Response to Submissions and Preferred Project Report

Concept Plan Modification 8, Major Development SEPP and State and Regional Development SEPP and Sydney Harbour SREP Amendments

Barangaroo South

Submitted to Department of Planning and Environment
On Behalf of Lend Lease (Millers Point)

Figure 1 – Difference between the exhibited EAR and PPR Concept Plan (Mod 8) site boundary

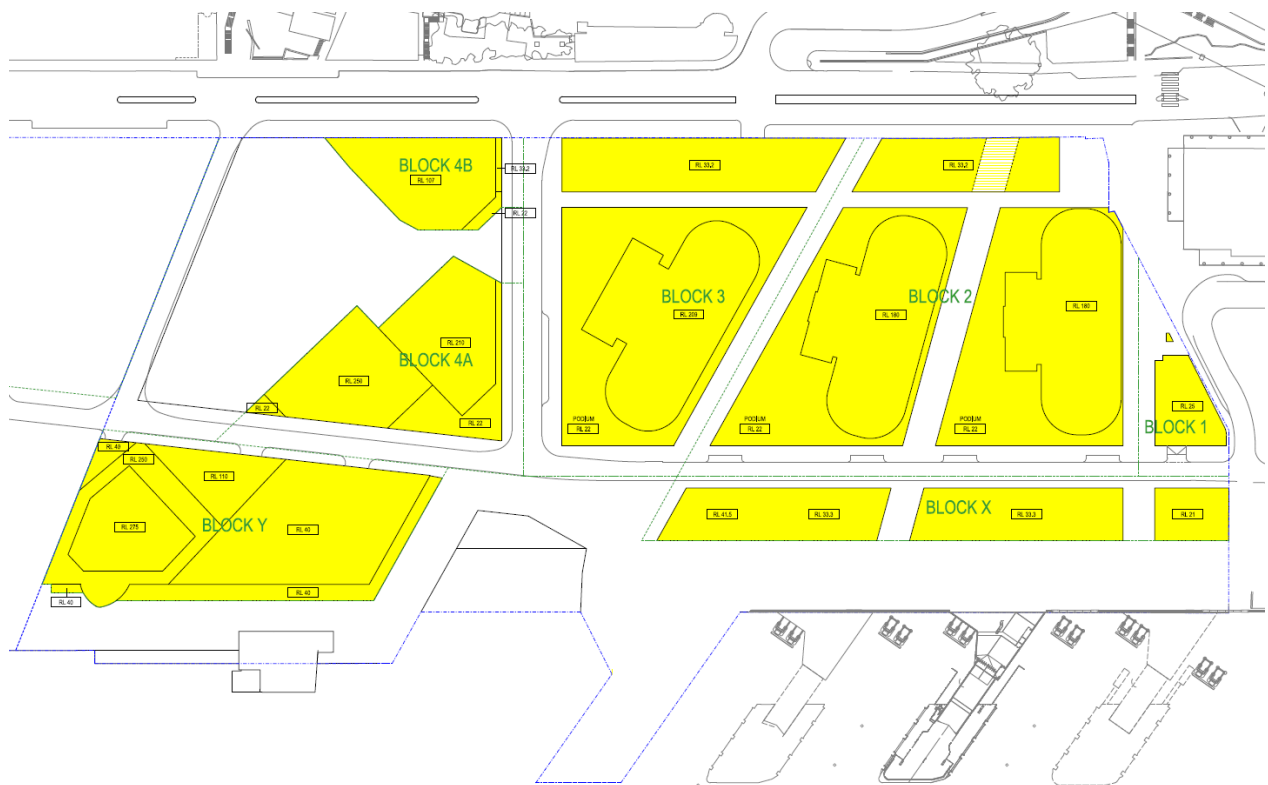
The Barangaroo site boundary has been adjusted slightly in order to accommodate a minor change to the proposed Public Pier. **Figure 1** illustrates the difference between the site boundary as shown in the Exhibited EAR and this PPR. **Figure 2** and **Appendix L** provides an updated version of the Building Envelope Plan.

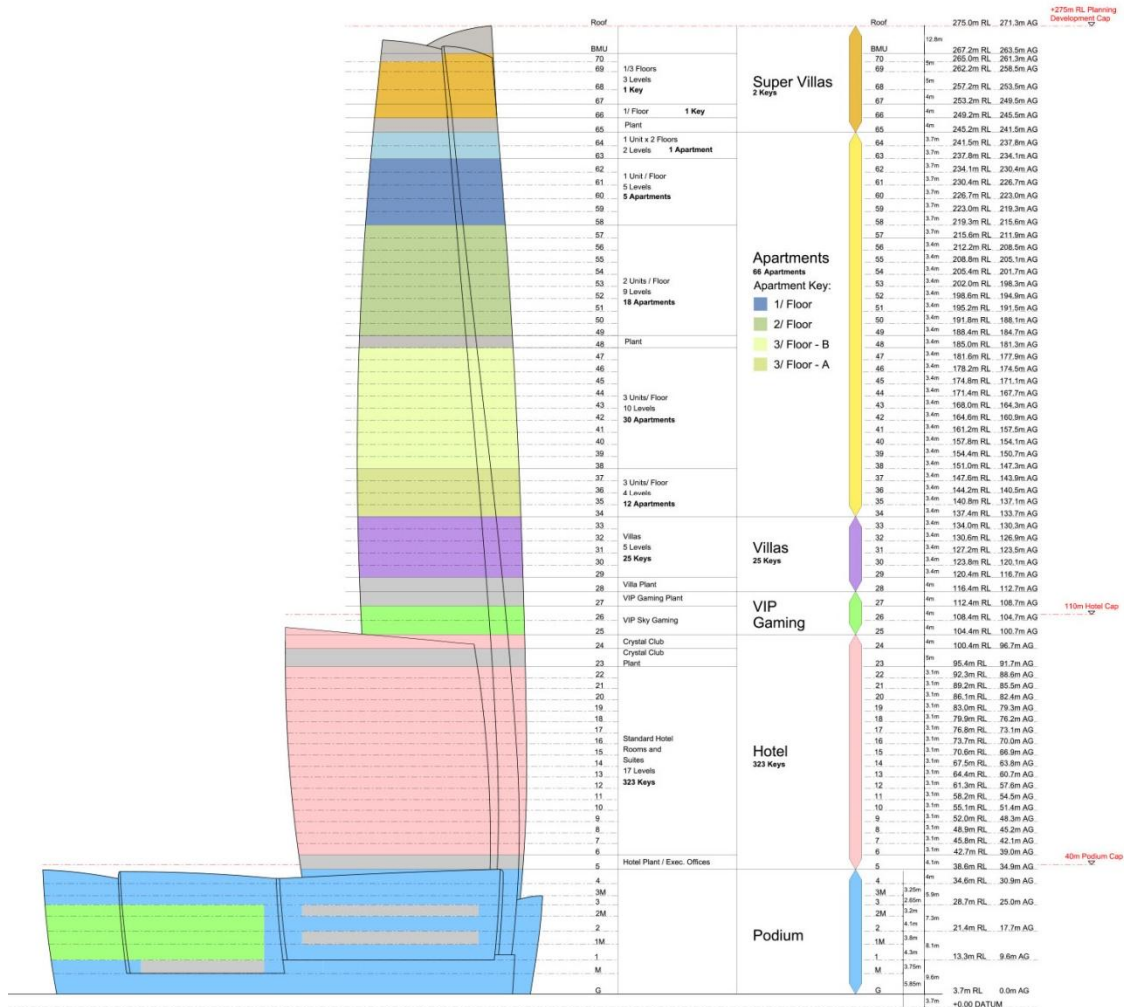
Include the rationale for the proposed scale and massing of the podium and its architecture, including details such as proposed formal and architectural modulation, visual and physical permeability, in relation to the objectives for Barangaroo, the site arrangement, movement patterns, surrounding public spaces and legibility

The scheme comprises three primary elements: the podium, the hotel (mid-rise) and the tower as per the diagrammatic section below.

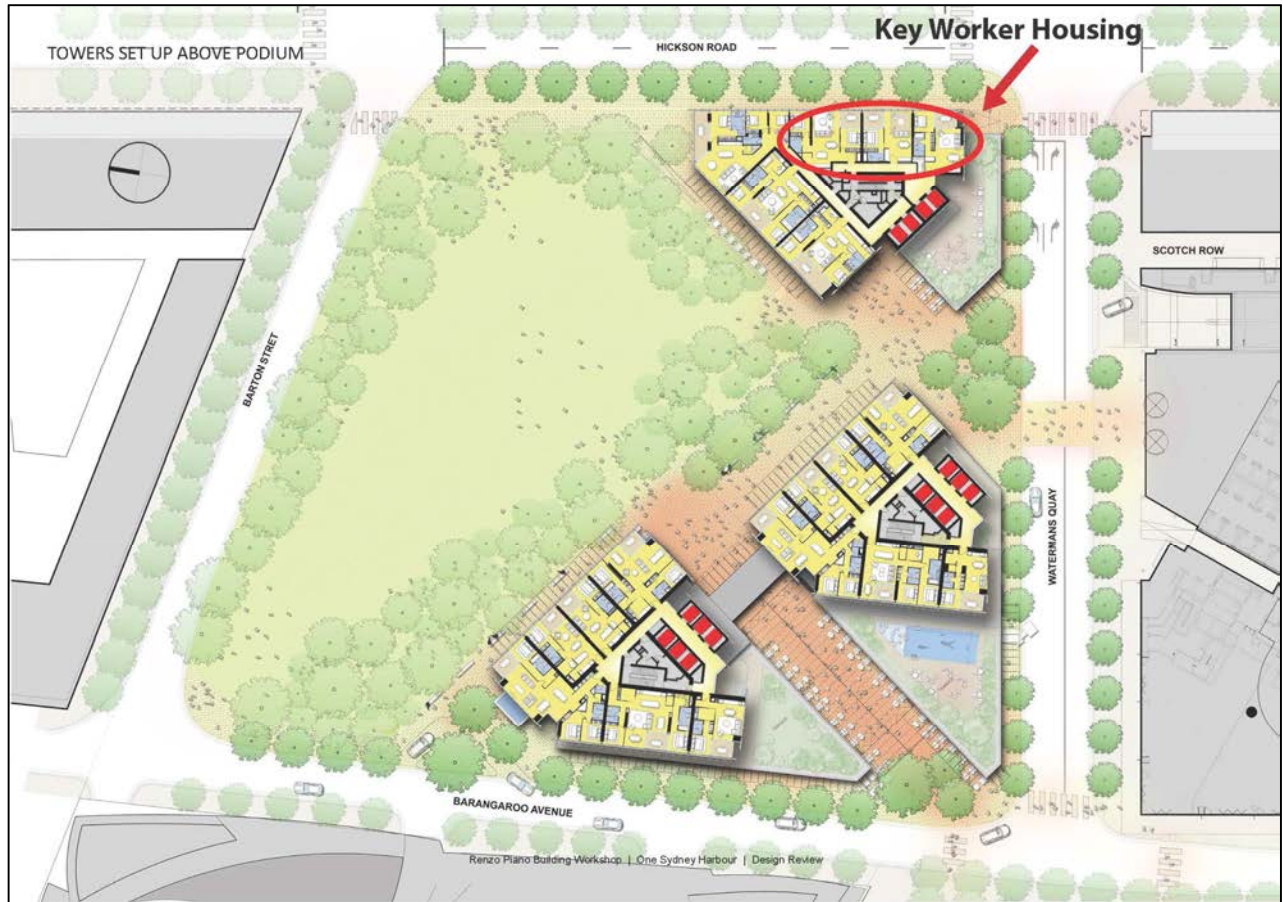
Identify where the affordable housing will be located, including access points

The current (MOD 7) Concept Plan commitment to provision of 2.3% of total residential floorspace as Key Worker Housing on the Barangaroo South site has remained unchanged in MOD 8. Given that the proposed residential floorspace on the site has been increased to a maximum of 154,000 sqm, Lend Lease's total commitment of Key Worker Housing GFA will also proportionally increase to approximately 3,542 sqm, assuming the full GFA cap is reached.
